DEVELOPMENT APPLICATION ASSESSMENT REPORT

Application Number:	DA2021/1043
----------------------------	-------------

Responsible Officer:	Adam Mitchell
Land to be developed (Address):	Lot 1 DP 303477, 43 Warraba Road NORTH NARRABEEN NSW 2101
Proposed Development:	Construction of a dwelling house
Zoning:	R2 Low Density Residential
Development Permissible:	Yes
Existing Use Rights:	No
Consent Authority:	Northern Beaches Council
Land and Environment Court Action:	No
Owner:	Cindy Lillian Reedy Paul Jamieson Reedy
Applicant:	Paul Jamieson Reedy

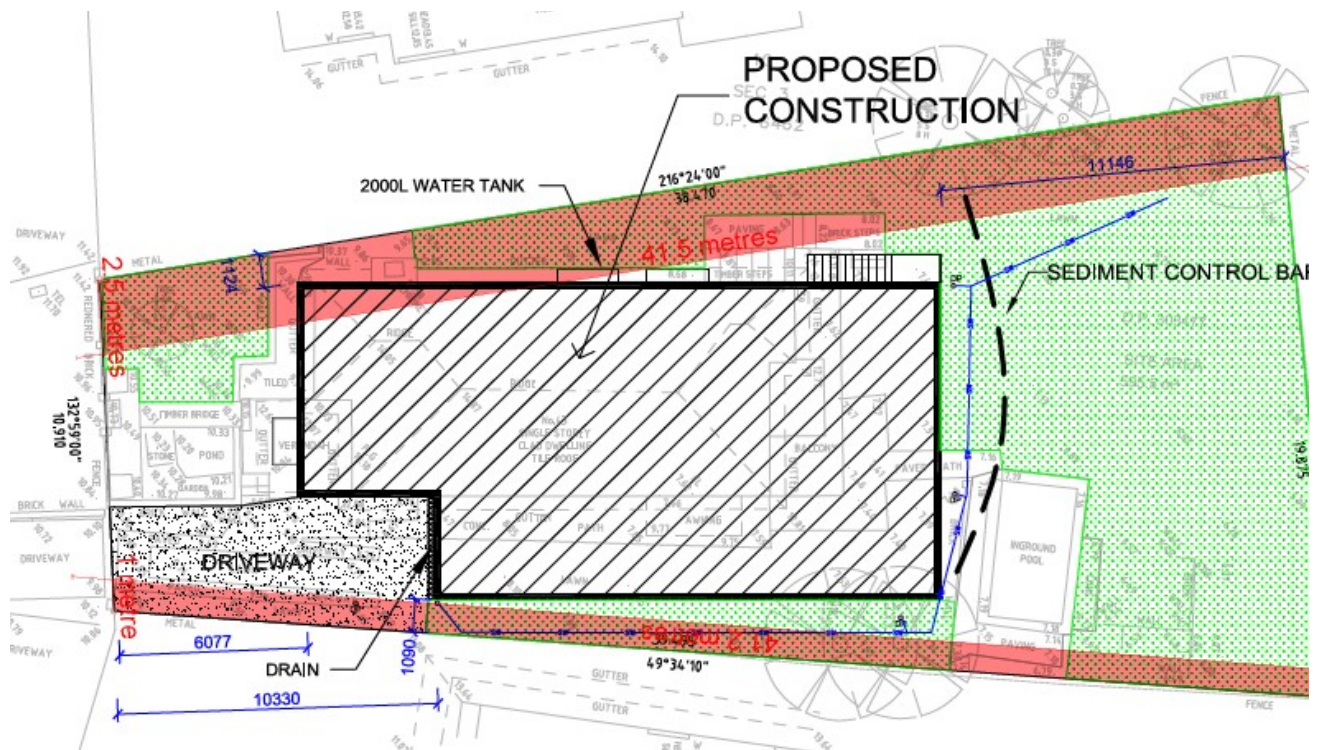
Clause D11.6 of the Pittwater 21 Development Control Plan 2014 prescribes a front boundary setback requirement of either 6.5m, or consistent with the established building line - whichever is the greater. The existing house achieves a front setback of 6.07m and this is retained under this application, but also seeks to construct a first floor with the same setback. The proposal therefore requires a 7% variation to the control requirement.

- *Achieve the desired future character of the Locality.*
Comment: The extent of non-compliance with the front boundary setback control is limited to a very minor element of the buildings frontage. The retention of the existing frontage and upwards addition is considered satisfactory.
- *Equitable preservation of views and vistas to and/or from public/private places.*
Comment: The development is not considered to result in the loss of any views or vistas from the public or private domain.
- *The amenity of residential development adjoining a main road is maintained.*
Comment: N/A Warraba Road is not a main road.

- *To preserve and enhance the rural and bushland character of the locality.*
Comment: The 40cm variation to the front setback does not materially alter the character of the area.

Having regard to the above assessment, it is concluded that the proposed development is consistent with the relevant outcomes of the Pittwater 21 Development Control plan 2014 and the objectives specified in s1.3 of the Environmental Planning and Assessment Act 1979. Accordingly, this assessment finds that the proposal is supported in this particular circumstance.

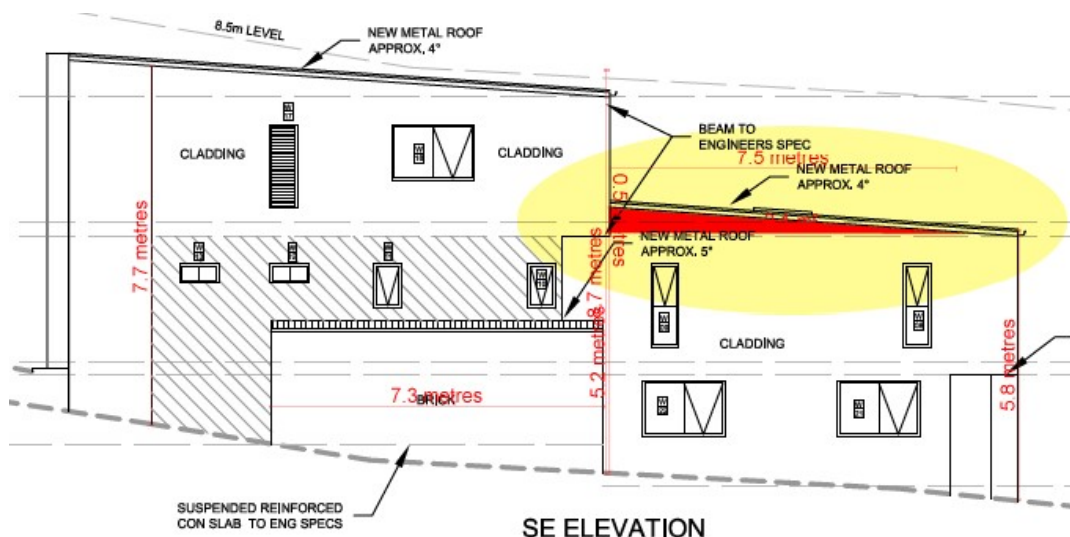
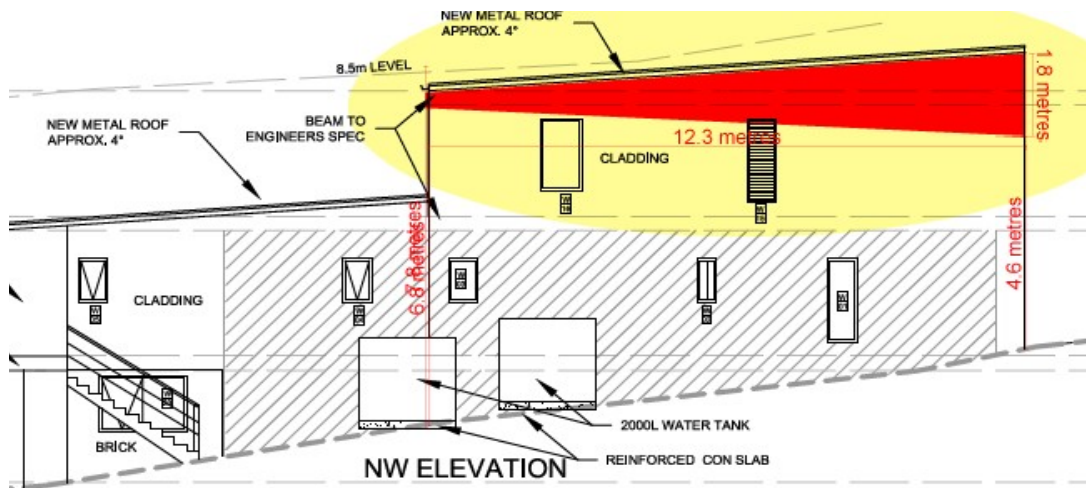
The northwestern setback is assessed as the 2.5m setback and therefore varies the requirement of the control by up to 55% for a portion of the dwelling. Below is a diagram with the prescribed side setbacks highlight in red, showing the front corner element of the building that encroaches the setback area.

- To achieve the desired future character of the Locality.*
Comment: The non-compliant side boundary setback is consistent with the setback established by the existing house, but seeks to construct atop of that thereby exacerbating the proportion of the building, but not increasing the level of non-compliance. The minimum setback of 1.1m increases as the site widens and therefore only a reasonably minor corner of the building encroaches the setbacks. The setbacks proposed do not detract from the proposals ability to achieve the desired future character.

Comment: Overshadowing and privacy are discussed under their respective DCP clauses elsewhere in this report. The non-compliant element of the building is located on the northern facade and thus does not result in any overshadowing to neighbouring properties.

Having regard to the above assessment, it is concluded that the proposed development is consistent with the relevant objectives of P 21 DCP and the objectives specified in s1.3 of the Environmental Planning and Assessment Act, 1979. Accordingly, this assessment finds that the proposal is supported, in this particular circumstance.
